RETREAT AT TIMBERRIDGE FILING NO. 4

CONSTRUCTION DRAWINGS

EPC STORMWATER REVIEW COMMENTS
IN ORANGE BOXES WITH BLACK TEXT

<p>RETREAT AT TIMBERIDGE FILING NO. 4 CONSTRUCTION DRAWINGS GRADING AND EROSION CONTROL PLAN</p>			
DESIGNED BY	PRA	SCALE	DATE 1-15-24
DRAWN BY	PRA	(H) 1" = 50'	SHEET 3 OF 14
CHECKED BY	(V) 1" = N/A	JOB NO.	1185.31

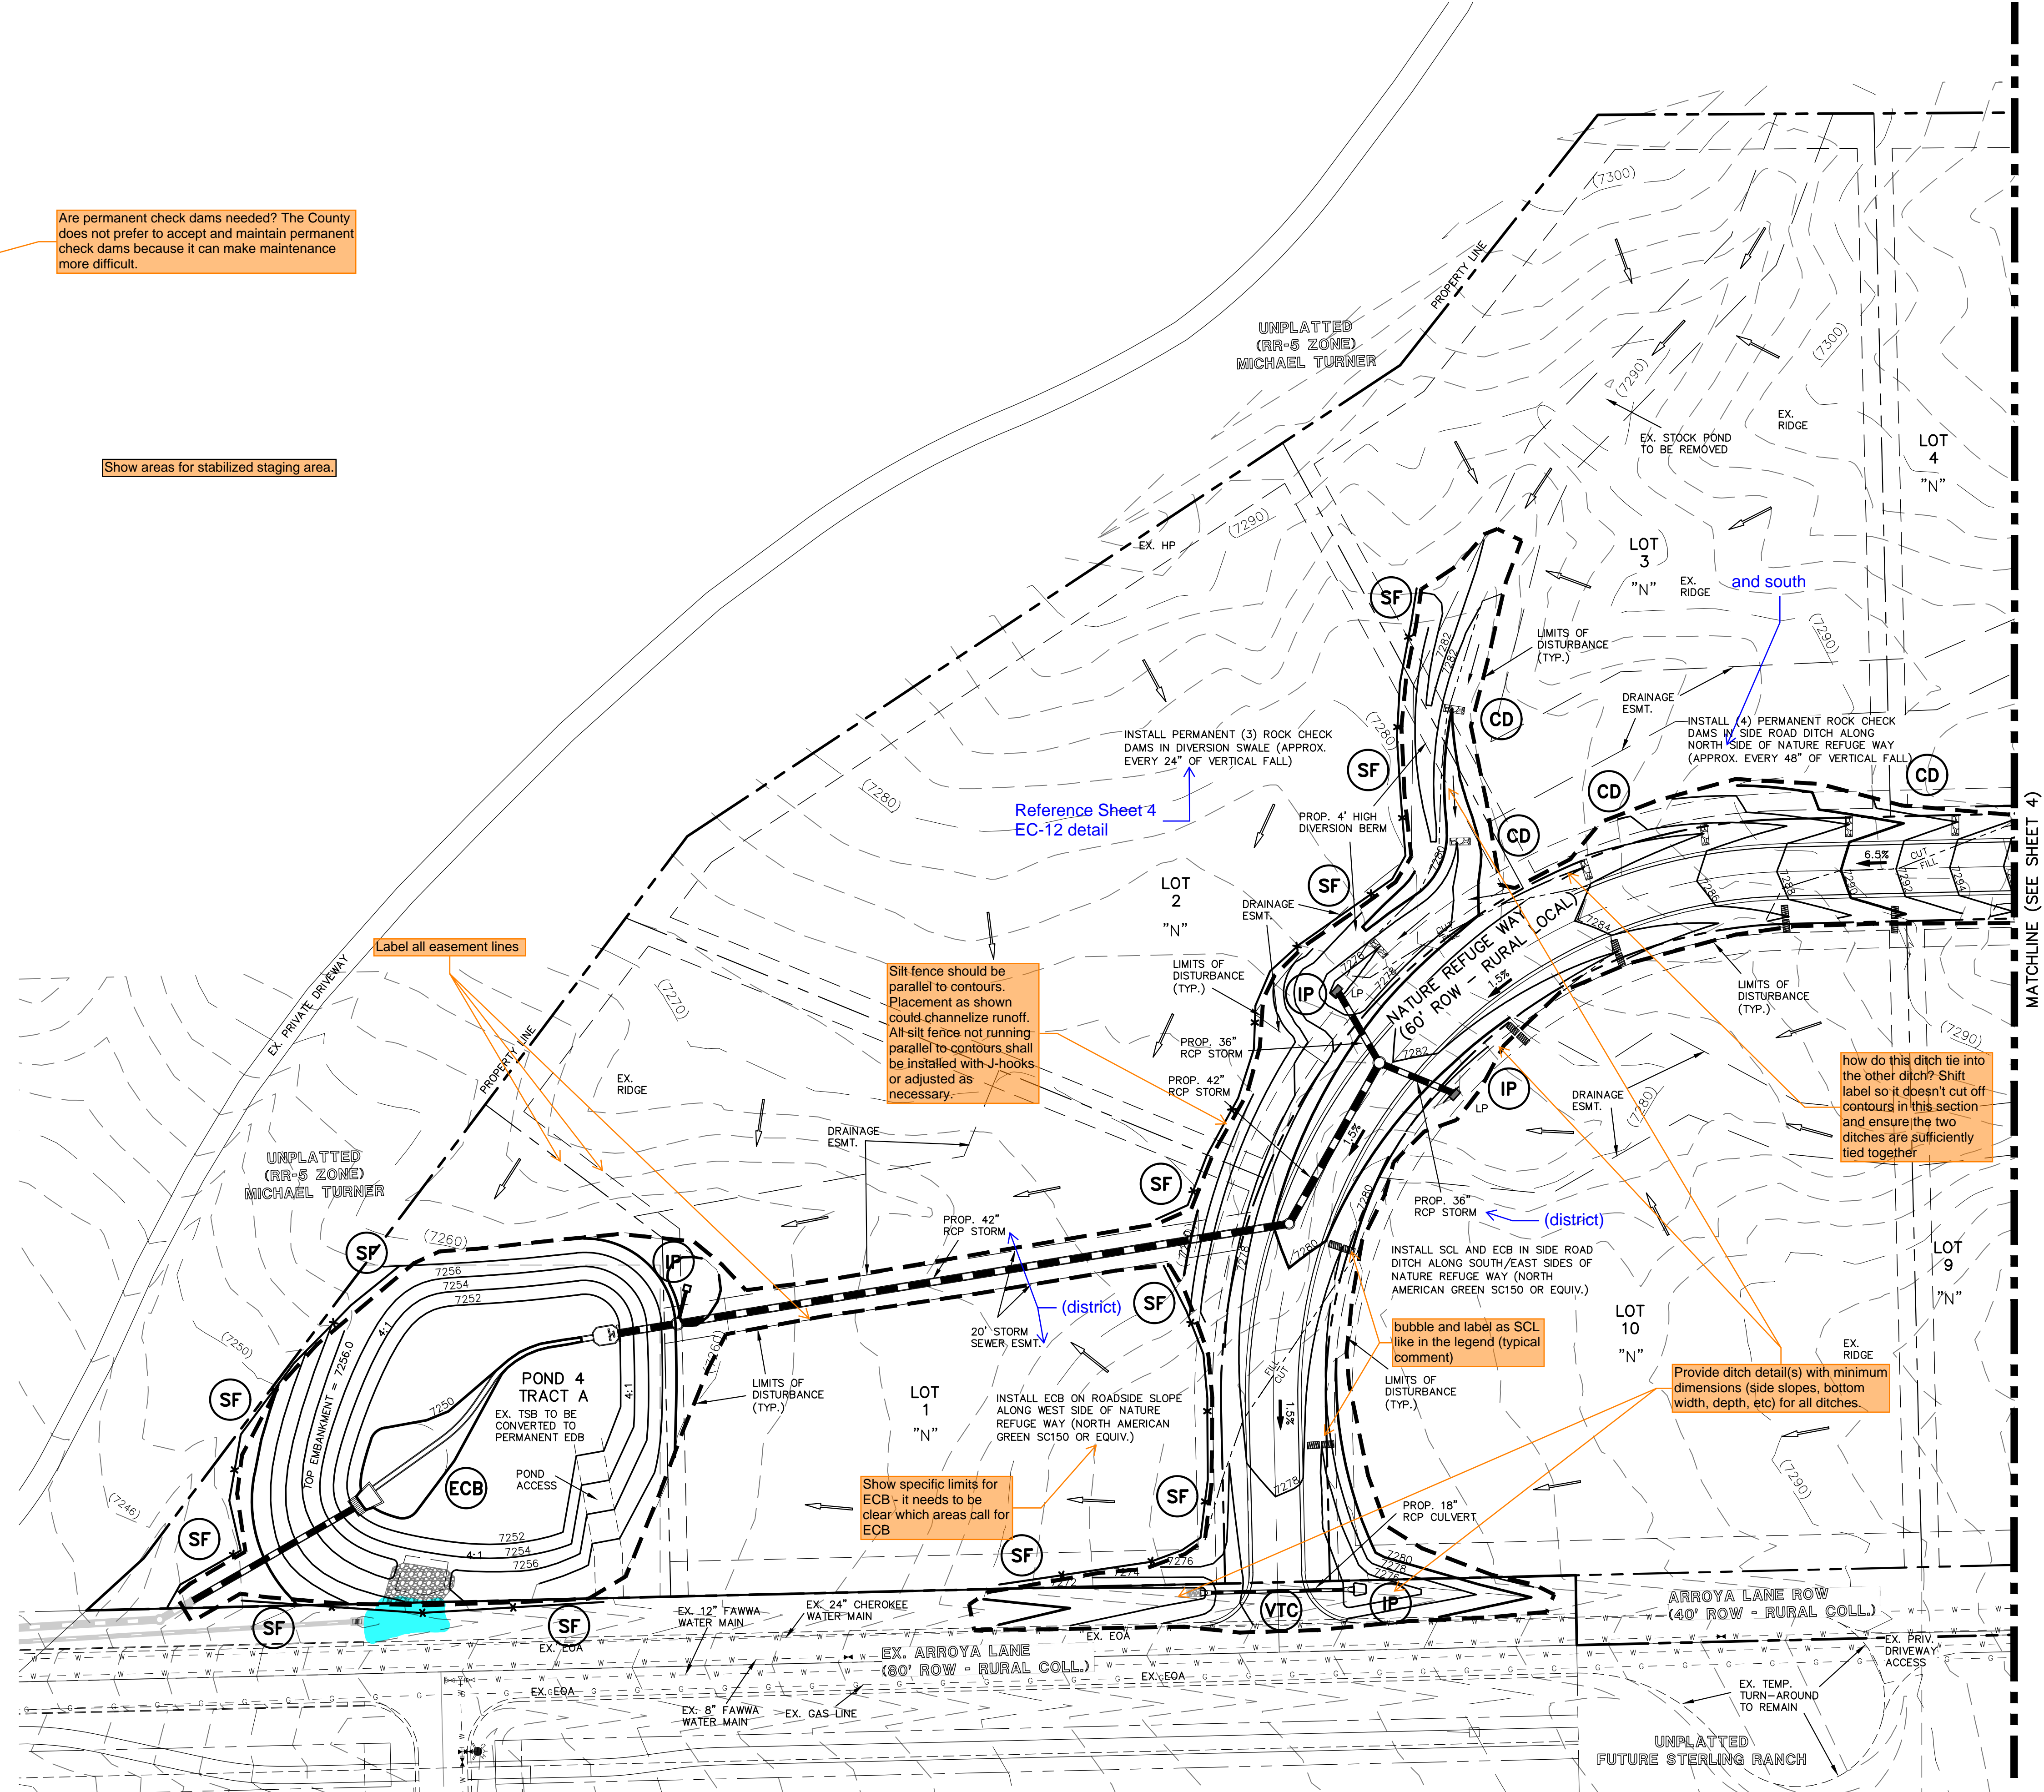
Are permanent check dams needed? The County does not prefer to accept and maintain permanent check dams because it can make maintenance more difficult.

Show areas for stabilized staging area.

Show areas for stockpiling and staging, clarify if they aren't anticipated, or add a note that those will be determined by the contractor

All are listed as through the vertical phase, but clarify which are to be final to be left and which are to be removed with final stabilization. Seeding and mulching are final and not on the phasing list.

RETREAT AT TIMBERIDGE FILING NO. 4
CONSTRUCTION PLANS
STREET LIGHT POLE LOCATION PLAN

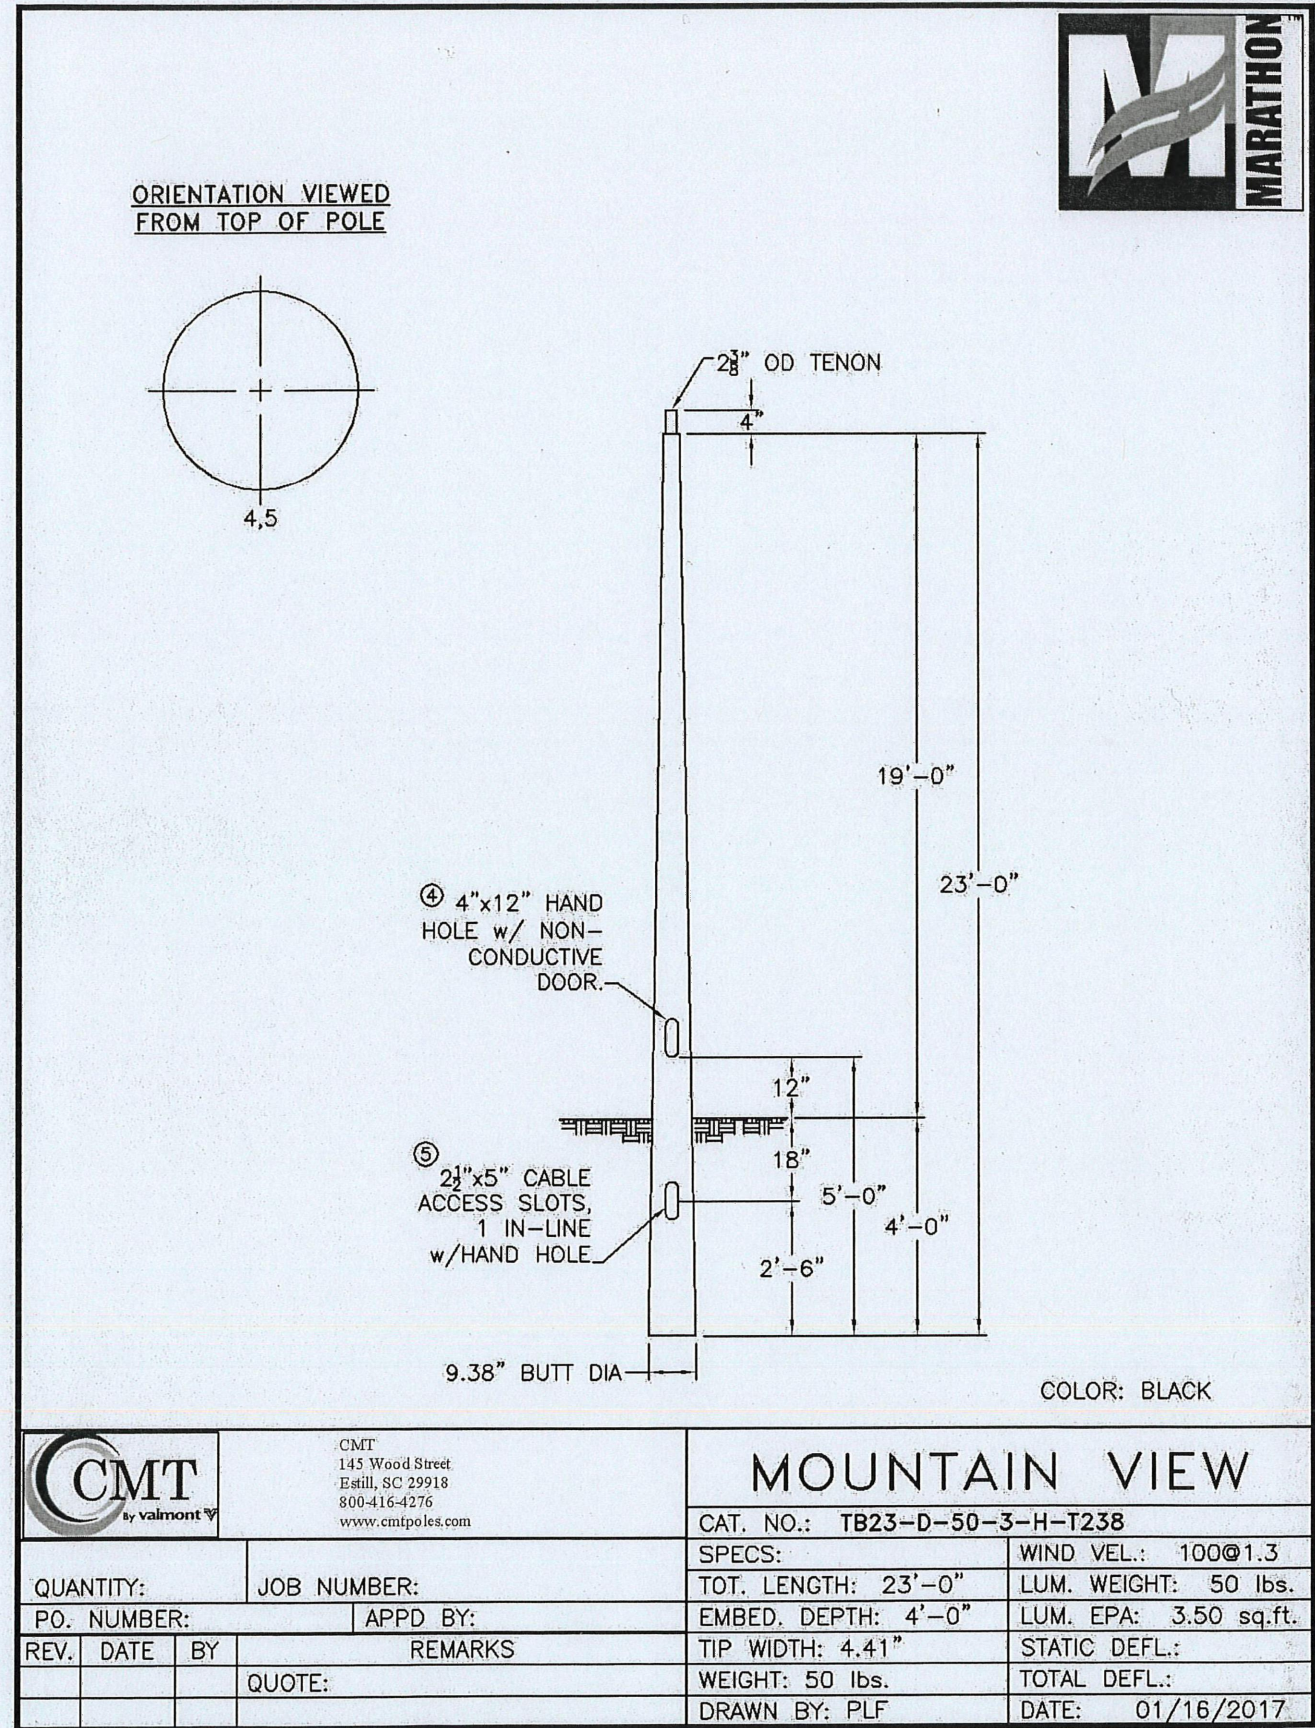
Provide a typical section on where light poles will be placed outside of clear zone and ditch

DETENTION FACILITY POND 4

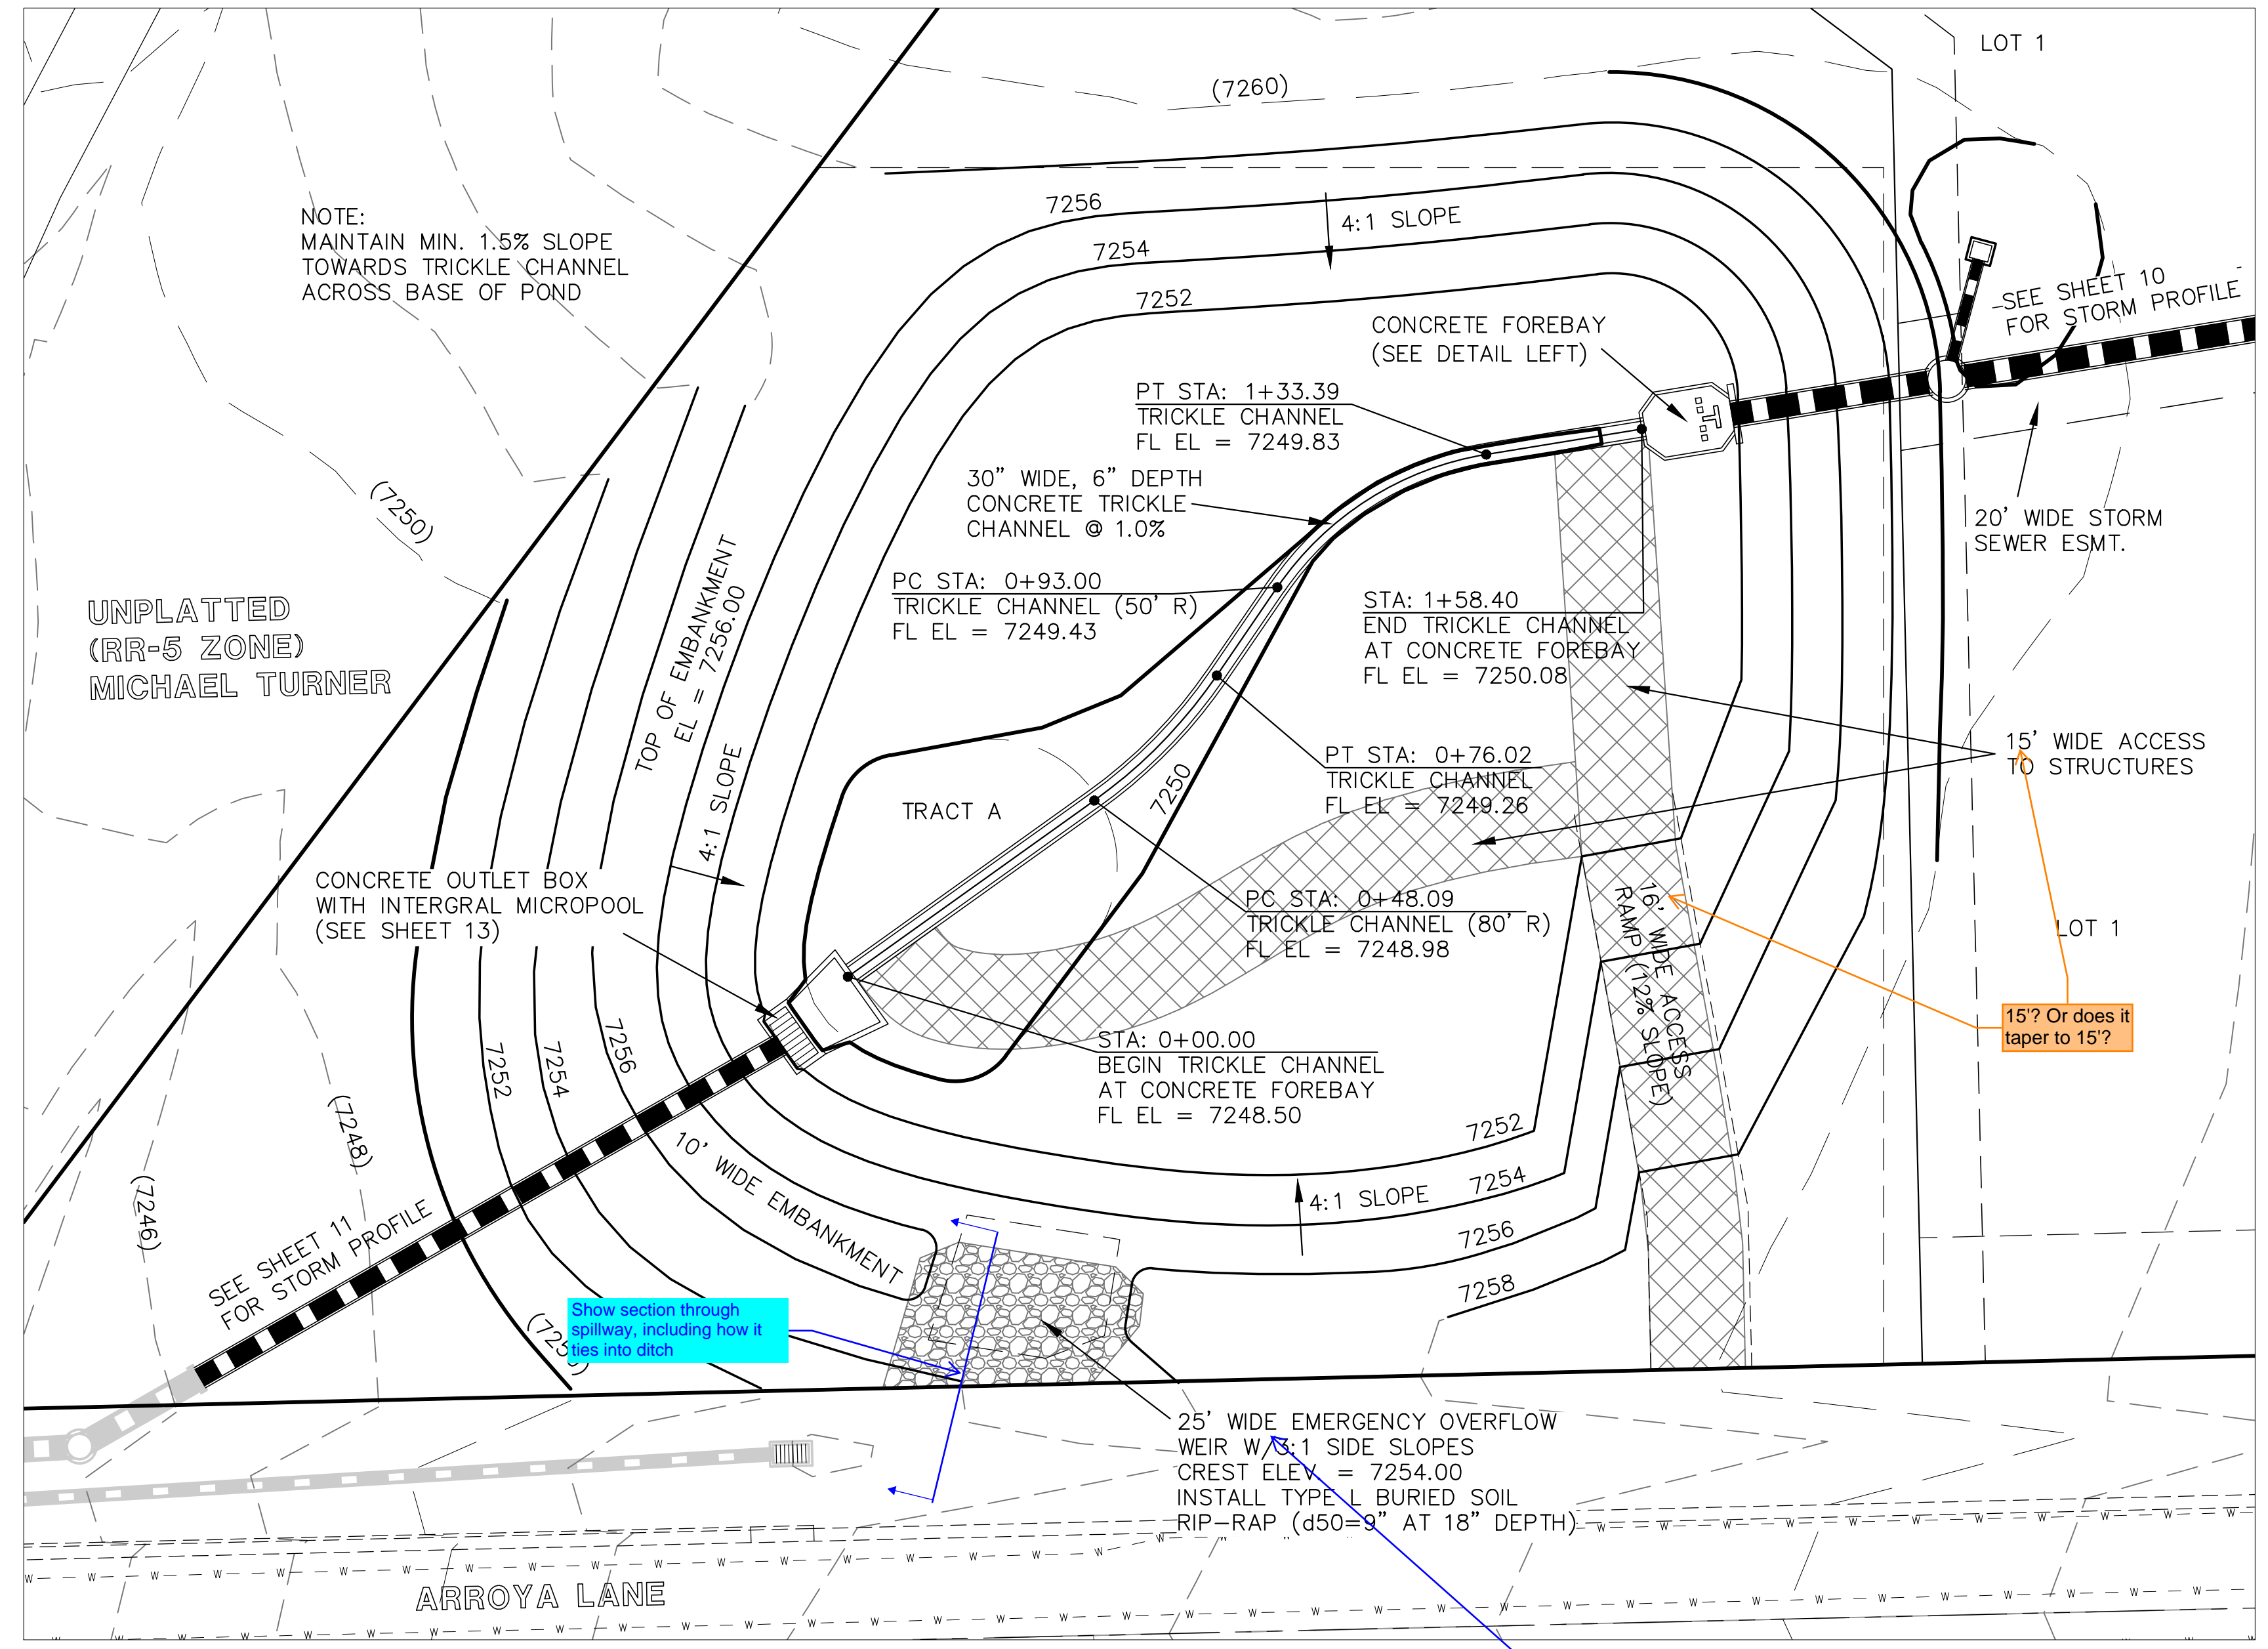
Existing (Filing 3?)
